Service Letter SL 31A	DOA - No. EASA.21J.020
--	----------------------------------	---------------------------

MTV-9-B-S/198-58B

Rework and Modification of Blade Preload Nut A-1368 and Blade Ferrule A-1367

Blade Ferrule A-1367

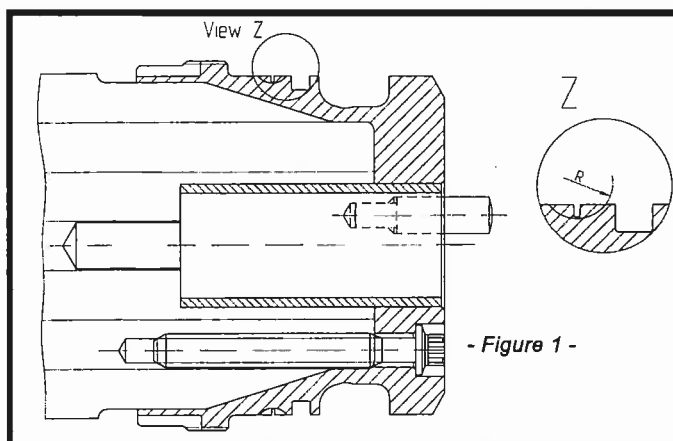
During operation the pre-load / bearing washer C-235 can wear into the Blade Ferrule A-1367.

The Blade Ferrule can be reworked according to this Service Letter in the affected area according to Figure 1.

Rework the worn area with a radius tool (radius 3-5 mm / 0,12 - 0,20 inch)

until the sharp worn area is round. Remove not more material so that a minimum diameter of 103,5 mm (4,07 inch) is still existing. After rework treat the area with Alodine.

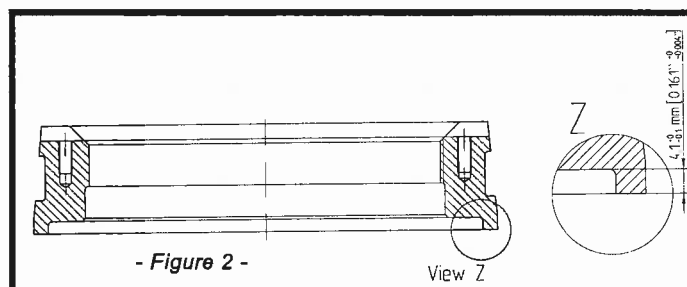
The Preload Nut A-1368 must be reworked before assembly that the outer O-ring has lower friction. The dimension in Figure 2 should be maximum 4,1 mm (0,161 inch).

Clamp the blade pre-load nut into a lathe and rework the nut until a dimension of 4,1 mm (0,161 inch) is given. After rework re-anodize nut or put Alodine on affected area.

Since mid of year 2004 the Preload Nuts are already manufactured with this dimension.
